Mungret Residential Development
Stage 1 Road Safety Audit

Proposed Development at Dromdarrig, Mungret, Co. Limerick

Stage 1 Road Safety Audit

Client:	Limerick City and County Council
Project Title:	Proposed Residential Development at Mungret, Co. Limerick
Document Title:	Stage 1 Road Safety Audit
File Name:	210121-20632-RP-0001_Stage1_RSA_Mungret_Site_P06

2.1 Problem: Traffic Calming

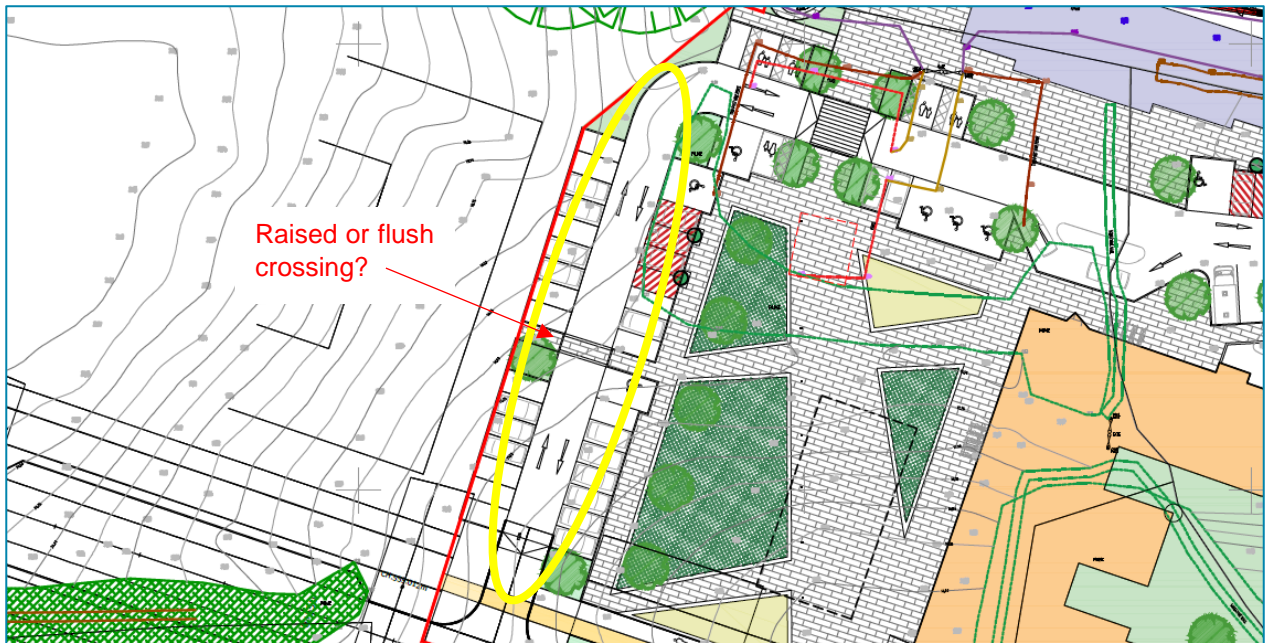
The western site access road which will provide the most direct access to the creche from the spine road has a very straight alignment which could be conducive to higher traffic speeds. It is not clear from the proposed site layout, if the crossing point located mid-way along the access road is to be raised or not. The likelihood and severity of all collisions is greatly exacerbated by higher speeds increasing the risk of a fatality and creating an unsafe environment for all road users especially pedestrians and cyclists.

Include a vertical traffic calming measure mid-way along the straight section of the access road to slow vehicles

Paragraph No. in Report	To Be Completed by the Design Team			To Be Completed by the Audit Team
	Problem accepted (yes/no)	Recommended measure accepted (yes/no)	Alternative measure (describe)	Alternative measure accepted by Auditors (yes/no)
2.1	Yes	Yes		
2.2	Yes	Yes	All tree species will accommodate visibility at junctions and corners	Yes
2.3	Yes	No	Parking spaces will be relocated to create a larger buffer between the parking spaces and the crossing.	Yes
2.4	Yes	Yes		
2.5	Yes	Yes	All tree species will accommodate visibility at junctions and corners	Yes
2.6	Yes	Yes	This will be provided through the introduction a raised table at this junction.	Yes
2.7	Yes	Yes		
2.8	Yes	Yes	These spaces can be accessed and egressed safely and in one movement.	Yes
2.9	Yes	Yes	These spaces can be accessed and egressed safely and in one movement.	Yes

2.2 Problem: Forward Visibility

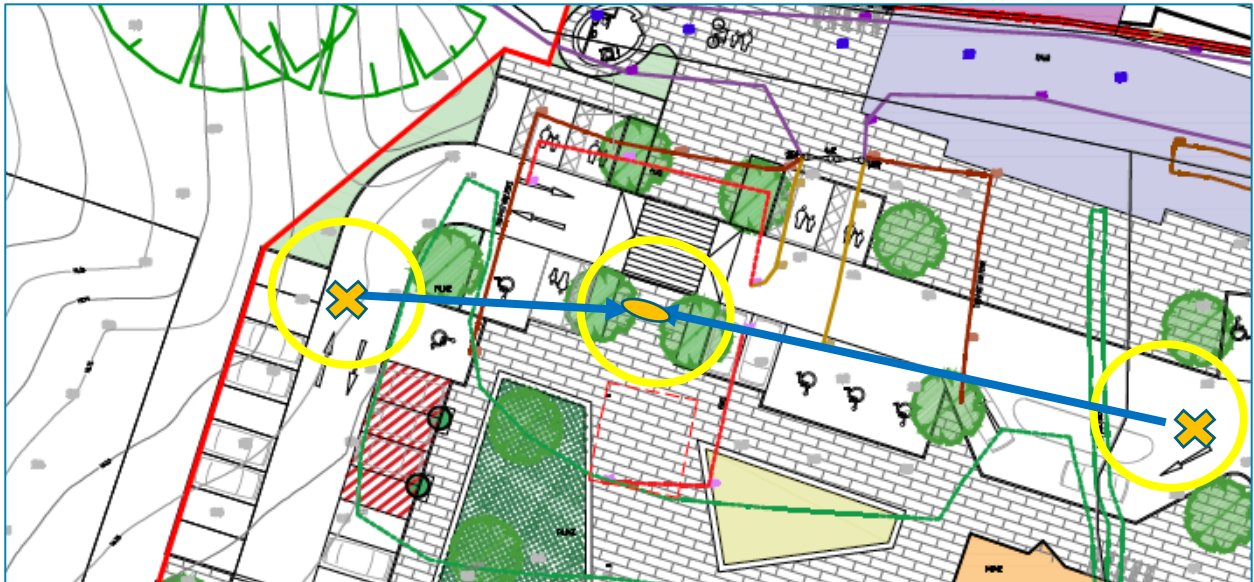
It is proposed to locate trees adjacent to the raised pedestrian crossing which provides access to the crèche. These trees will reduce the forward visibility of the crossing increasing the risk of a collision with a pedestrian. Maximising visibility is an important safety measure especially consider the adjacent sharp bend in the approaching road.

Ensure that the trees (and parking) do not reduce the forward visibility of motorists to see a pedestrian (especially a small child) about to cross. Tree types should be of a slender girth when mature and have a truck clear of side growth to a height of 1.8m. Also refer to Problem 2.3.

2.3 Problem: Parking close to Pedestrian Crossing

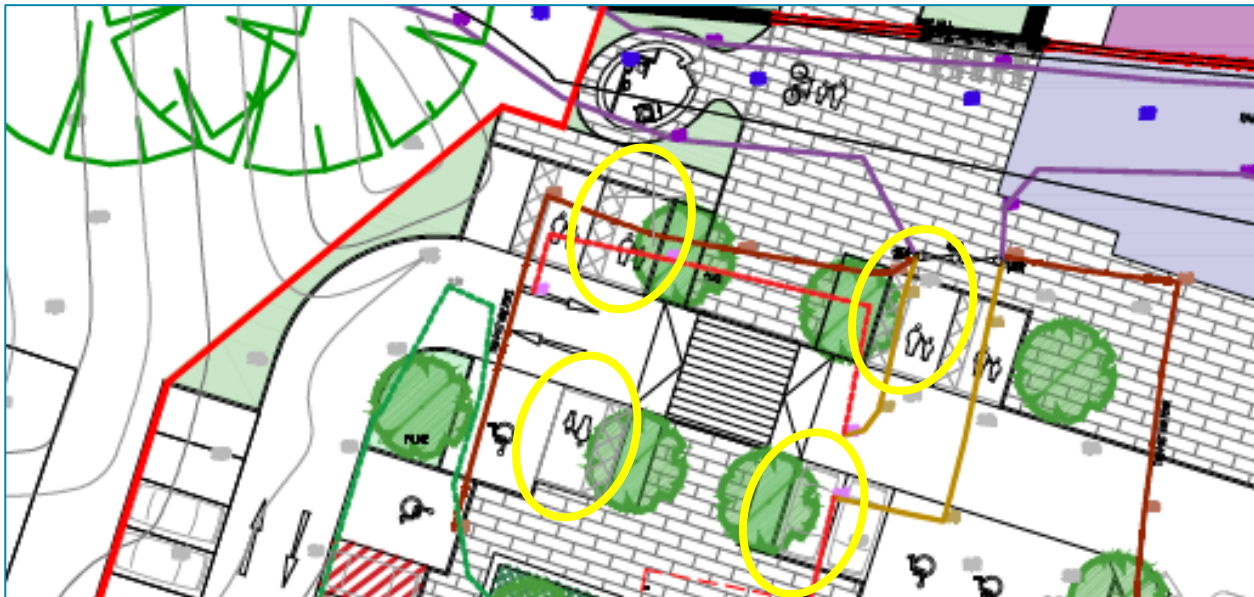
Parking bays are located very close to a significant pedestrian crossing, providing access to the creche from the set-down area. There is a danger that a motorist might need to reverse onto the crossing in order to exit a parking space increasing the risk of a collision with a pedestrian. Also, some of the parking bays to the south of the crossing may reduce the forward visibility of the crossing. Also refer to Problem 2.2.

Increase the buffer between the crossing and the adjacent parking spaces. This may require removing some of the parking bays. Remove all of the parking to the southwest of the crossing.

2.4 Problem: Shared Route to Creche

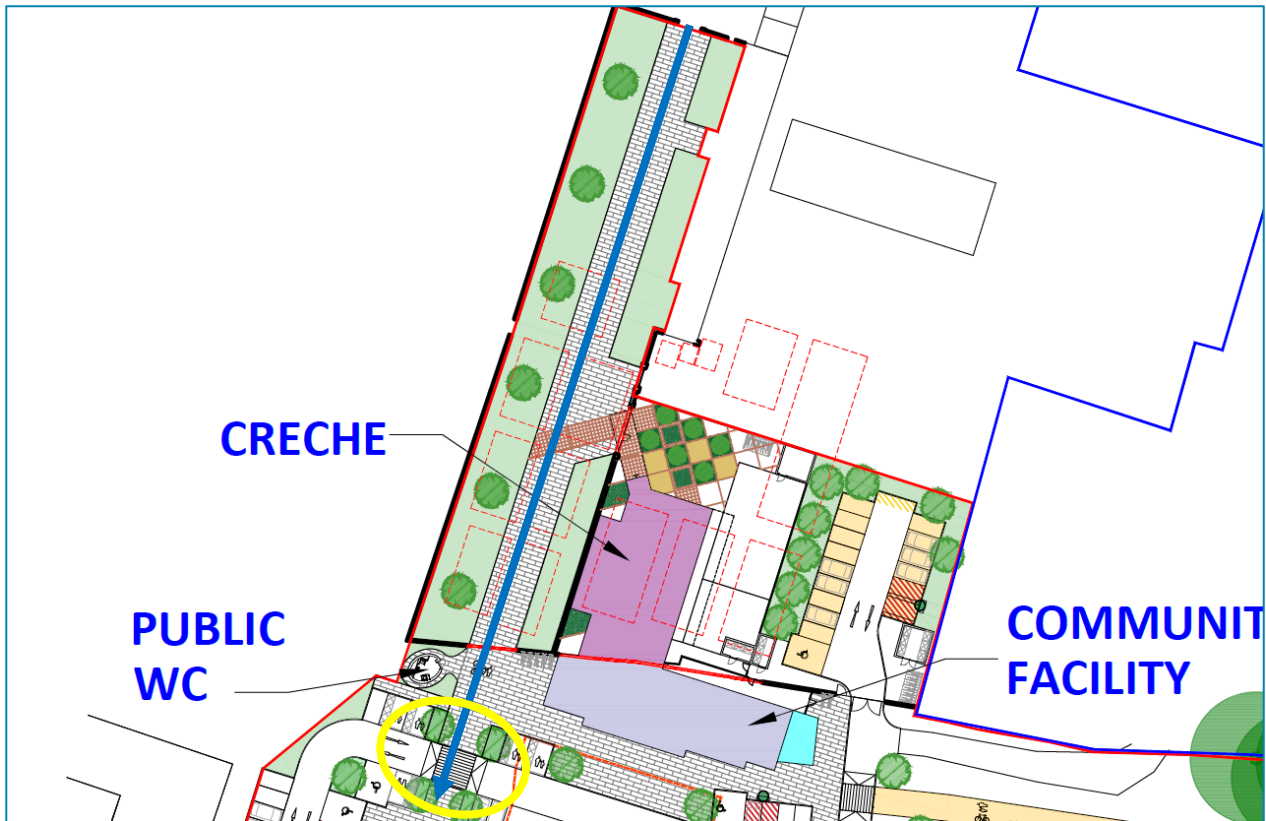
The shared pedestrian/cyclist route which provides access to the creche has a straight alignment, bounded by a row of trees and leads directly onto a pedestrian crossing. There is a danger that small children might run or cycle straight across the road without paying due caution to traffic. The adjacent parking spaces (refer also to Problem 2.3) form a kind of tunnel effect and reduces inter-visibility between motorists and pedestrians. This could lead a child running/cycling in front of a passing vehicle and being struck.

The Design Team should consider installing two or three bollards to encourage children to slow down and be more cautious on approach to the crossing. Ensure that different surface materials of varying contrast are used to clearly distinguish the crossing from the other shared pedestrian/cyclist areas. Ensure that the crossing is well lit with the appropriate tactile paving.

2.5 Problem: Sight Lines at Junctions

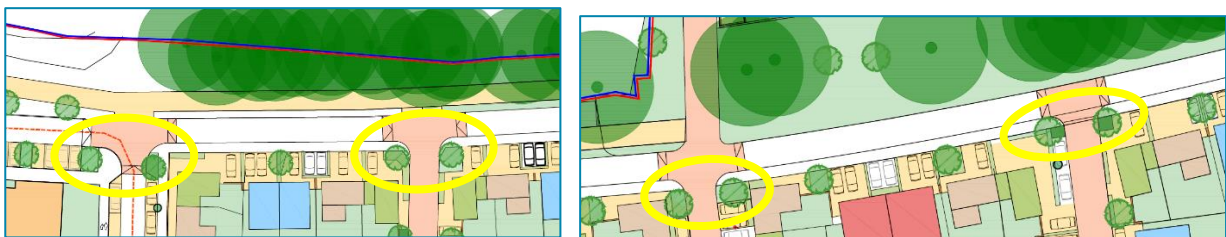
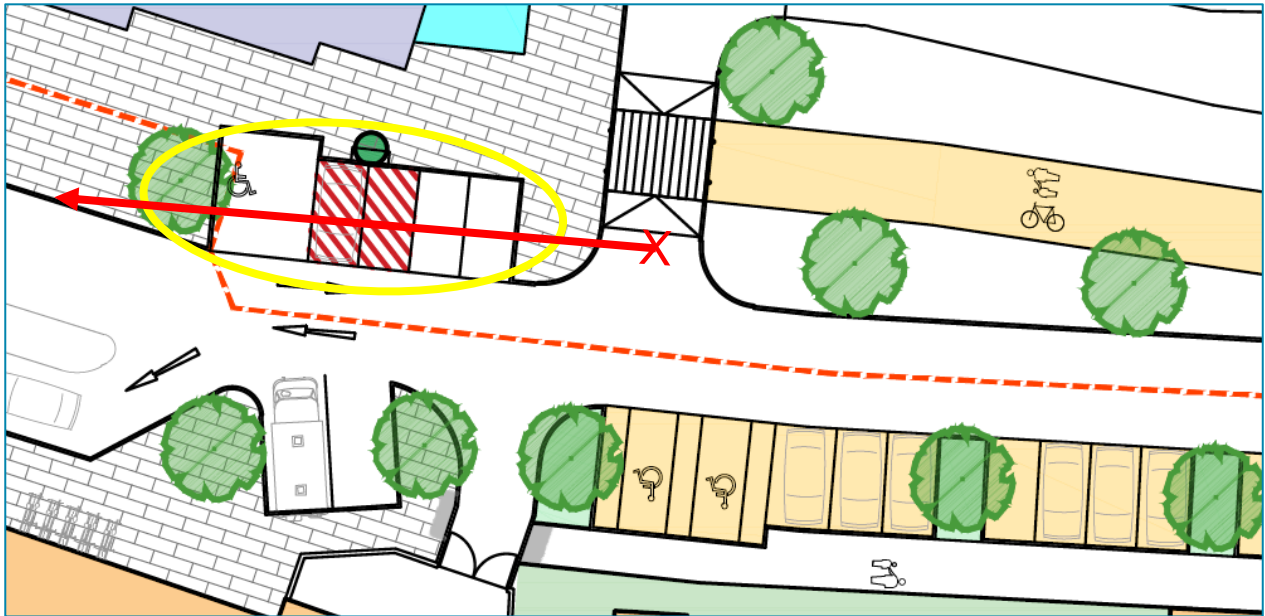
It is unclear from the scheme drawing if the necessary sight lines can be achieved at many of the internal junctions due to proposed tree planting or car parking close by. Reduced visibility increases the risk of 'side-seep' or 'rear-end shunt' type collisions.

Ensure that all internal junctions have the necessary sightlines in accordance with DMURS.

2.6 Problem: Lack of Uncontrolled Crossings

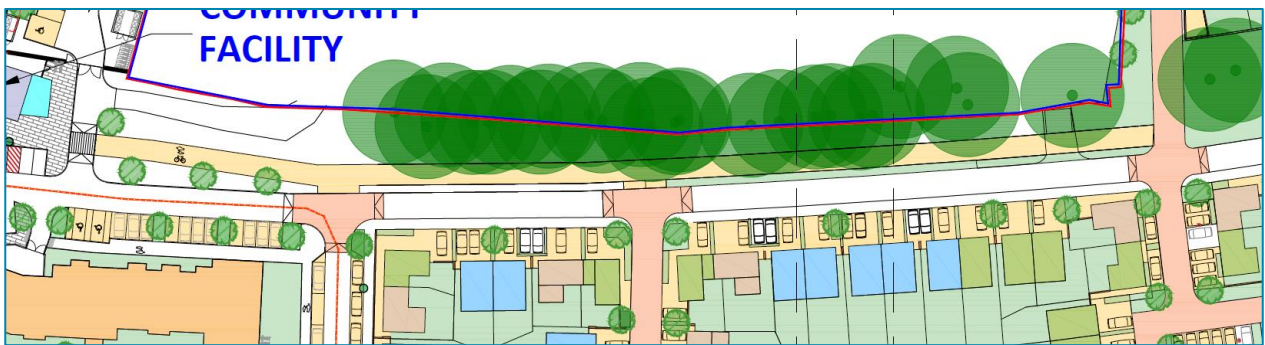
There appears to be a lack of uncontrolled crossings for pedestrians wanting to access the 'Shared Leisure Route' which runs along the northern boundary from other parts of the development. This may lead to pedestrians crossing the street at unsafe locations.

The Design Team should ensure that there is appropriate crossing points and connectivity from the development to the Shared Leisure Route.

2.7 Problem: Lack of Tactile Paving at Pedestrian Crossings

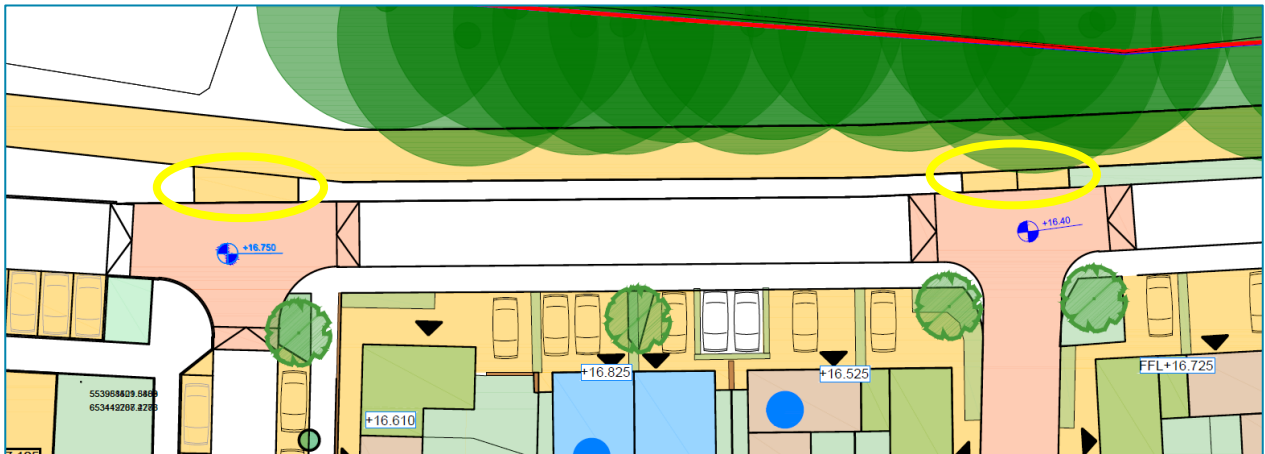
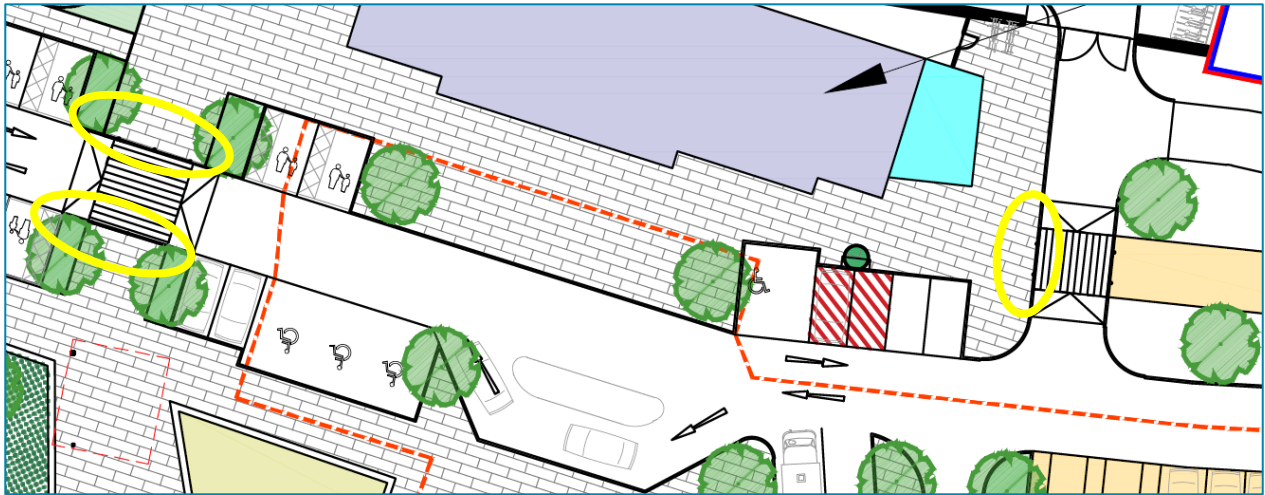
No tactile paving is prescribed at pedestrian crossings which could lead to pedestrians with a visual impairment stepping out onto the carriageway and in front of a passing vehicle.

Ensure that the correct tactile paving is used at the correct location (i.e. on the desire line) at each pedestrian crossing for the entire scheme.

2.8 Problem: Turning Area in Carpark

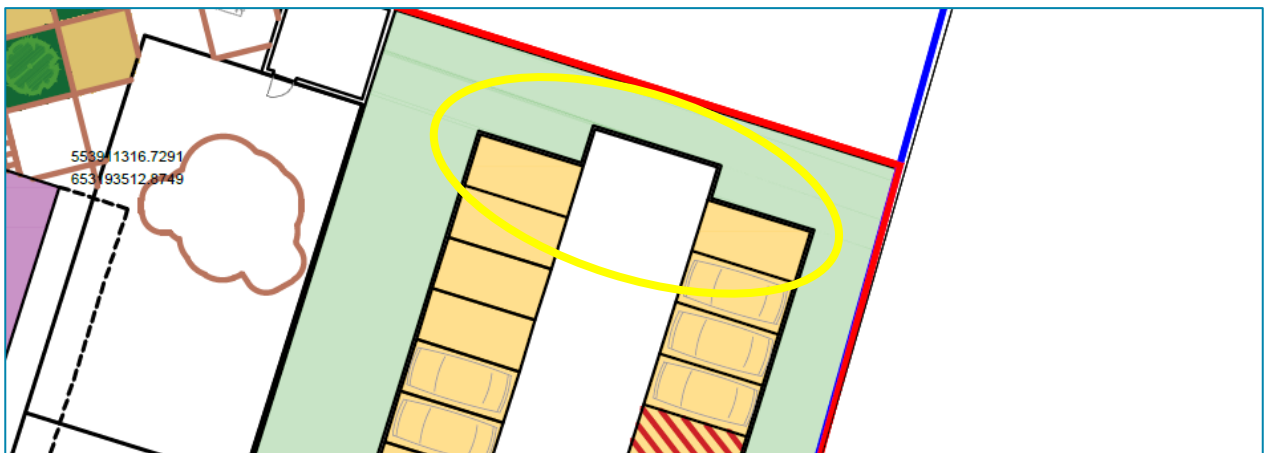
It is not clear if motorists can safely egress from the end parking spaces when all other parking spaces are occupied by a vehicle. This could lead to an increased risk of collision with another vehicle.

Carry out a vehicle path sweep assessment to ensure that motorists can safely park and vacate the end parking spaces and if not, design accordingly.

2.9 Problem: General Parking Movements

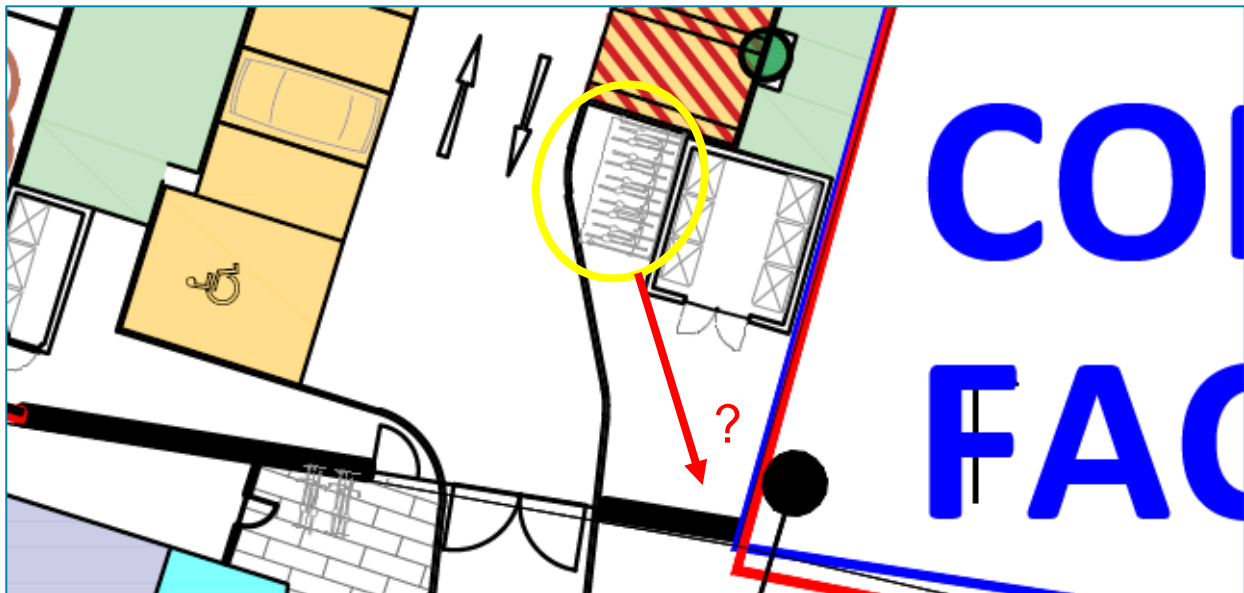
It is not clear from the drawings, if there is sufficient space for vehicles to carry out the required movements, particularly for parking. Some parking spaces appear tight and may take several movements to access/egress the spaces. Parking spaces which are difficult to use may increase the risk of an incident.

Review all of the parking areas within the site. Carry out a swept path analysis to illustrate that all spaces can be accessed and egressed safely. Consider keeping parking spaces away from junctions and raised tables / pedestrian crossings to increase safety and manoeuvrability.
